Door Handle and Safety Latch Components

SICC_068A

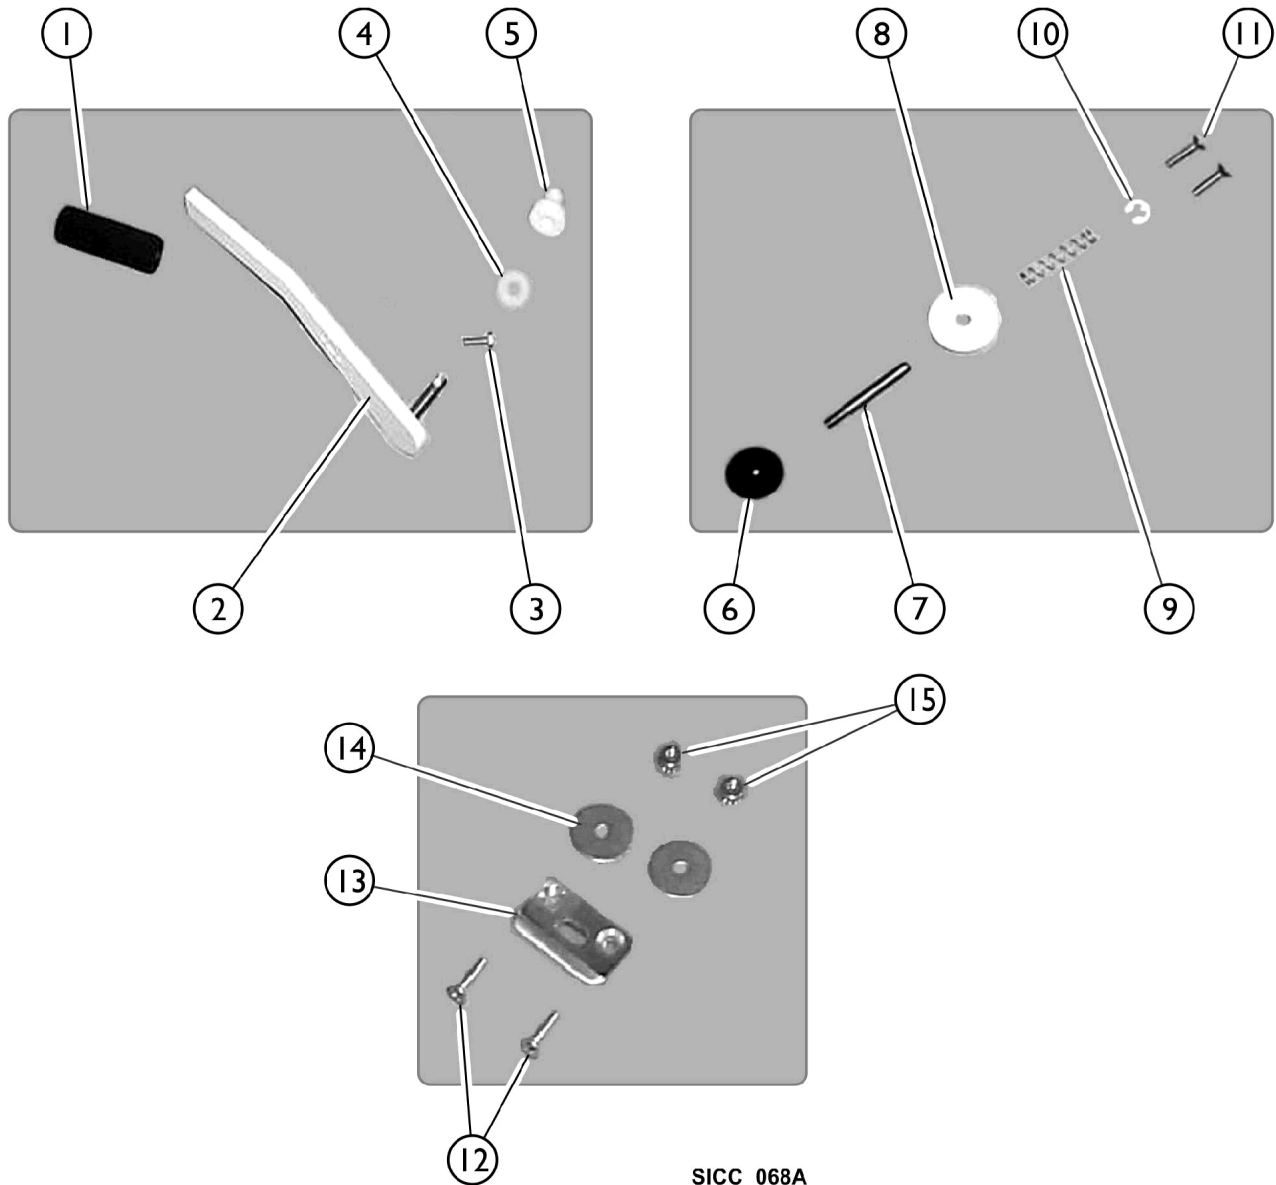
There is a difference between old style and new style handles (Item #2).

Old Style: Distance between handle pin/hole for the latch pin is 3-3/4"

New Style: Distance between handle pin/hole for the latch pin is 3".
